SUBJECT: MEETING NOTIFICATION AND TRANSMITTAL OF AGENDA

MEETING MINUTES FROM THE
MARICOPA ASSOCIATION OF GOVERNMENTS
STANDARD SPECIFICATIONS AND DETAILS COMMITTEE

July 11, 2007

DETAIL NO. 535

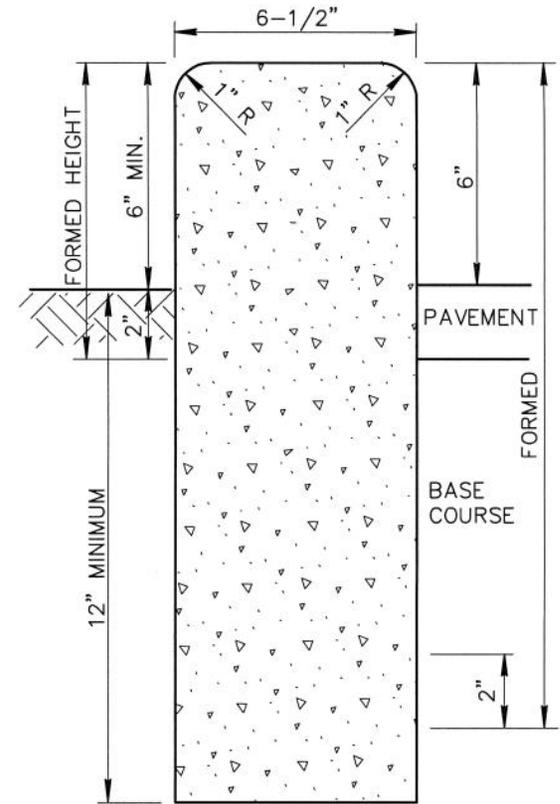
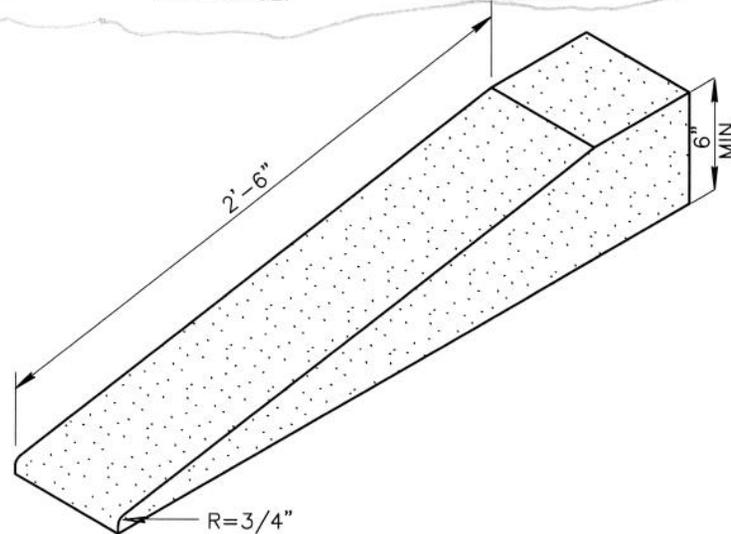
a. **Case 07-01A – Miscellaneous Corrections:** Dimension correction to Detail 535 catch basin type “F”. Paul Nebeker requested the detail include an invert depth dimension. James Bond agreed and will have the change included with the revised detail for the next meeting. Members were requested to be prepared to vote on this case at the next meeting.

**C.M.P. CONNECTION TO MAIN STORM DRAIN
24" PIPE AND SMALLER**

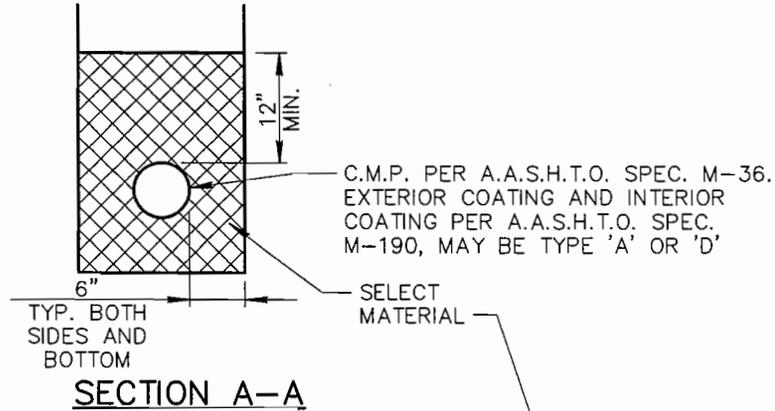
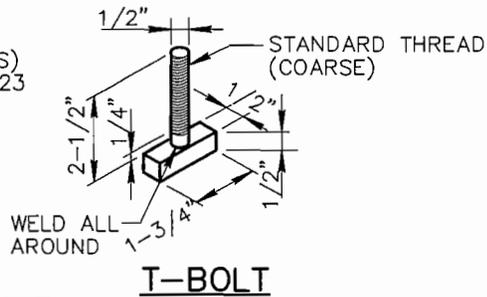
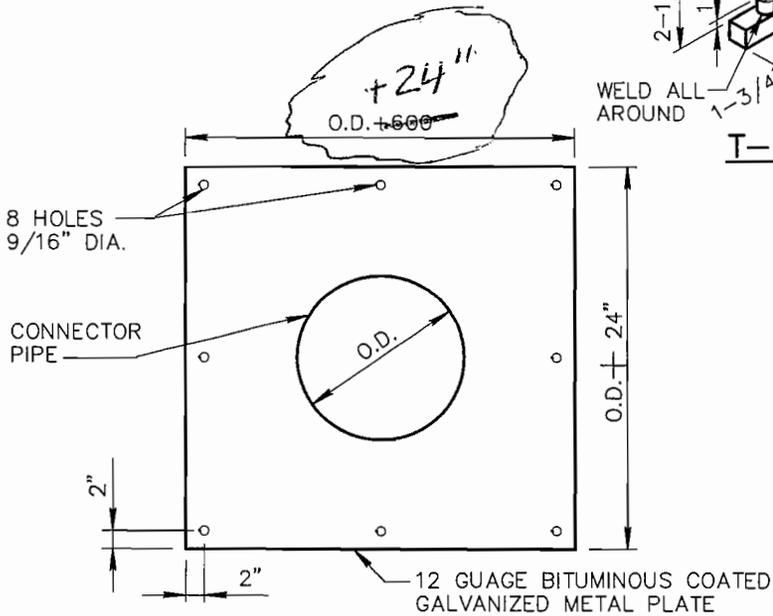
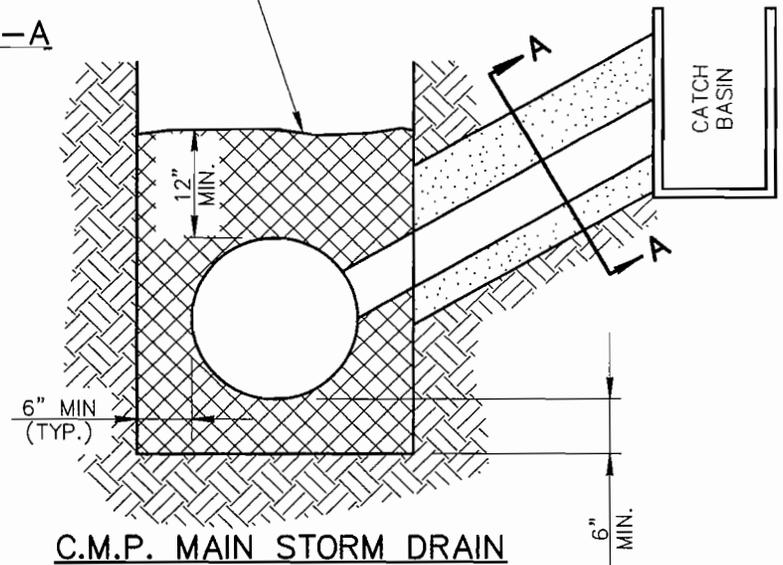
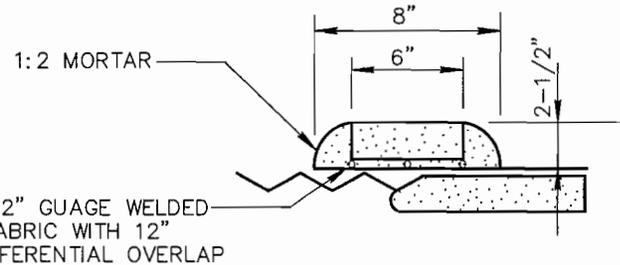
d. **Case 07-01D – Miscellaneous Corrections:** Bob Herz presented a correction to Detail 510 titled “Corrugated Metal Pipe and Installation”. He found that a metric dimension of 0.6m was noted on the CMP connection detail. This is an English detail and should be note as 24 inches. Members were requested to be prepared to vote on this case at the next meeting.

201

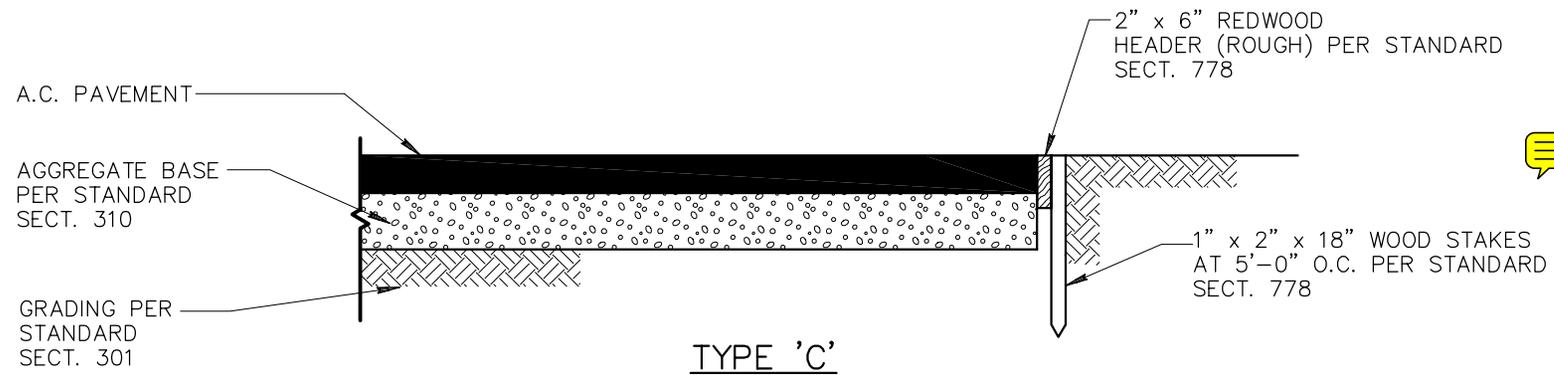
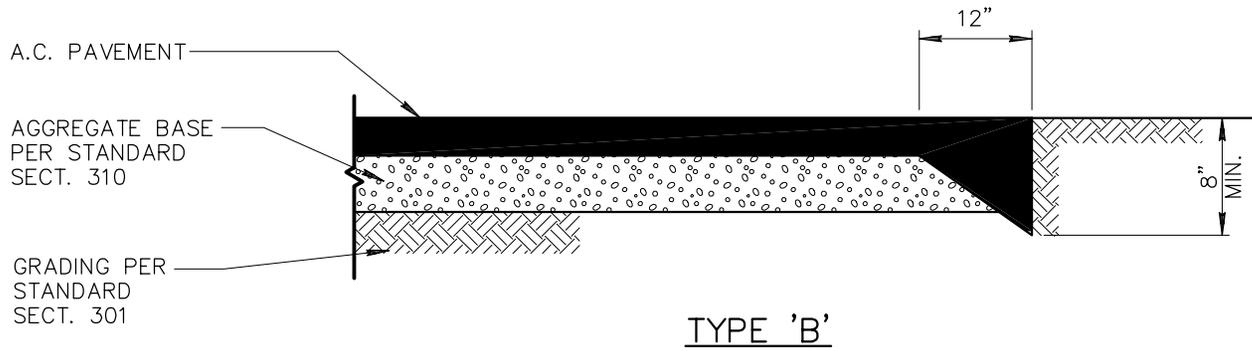
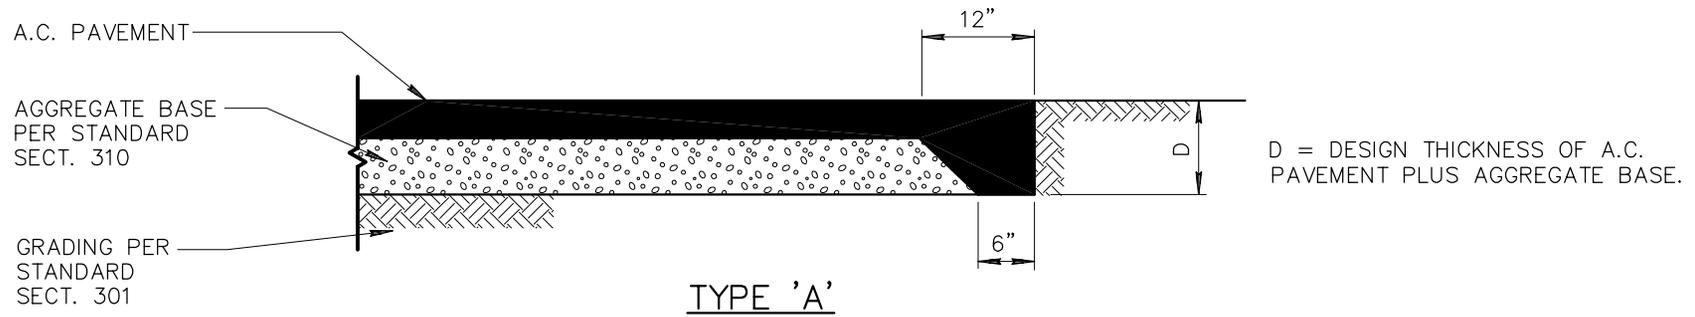
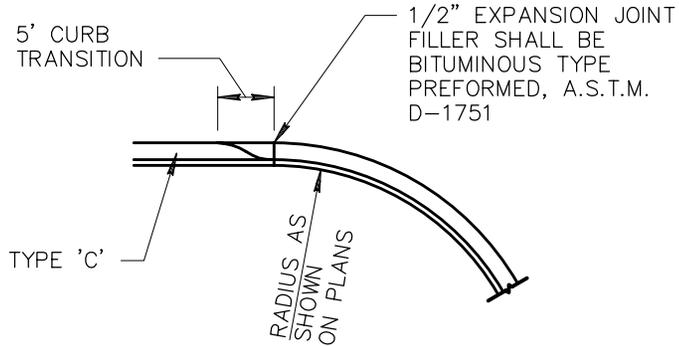
m. **Case 07-10 – Deletion of Obsolete Details:** Deletion of Type C redwood pavement terminations in Detail 201 and deletion of curb warning beacons in Detail 221. The committee had no discussion on this item. Members were requested to be prepared to vote on this case at the next meeting.

1. Delete the Type C redwood header pavement termination from Detail 201 Pavement Section at Termination.
2. Delete the Curb Warning Beacon detail from Detail 221 Curb and Gutter.
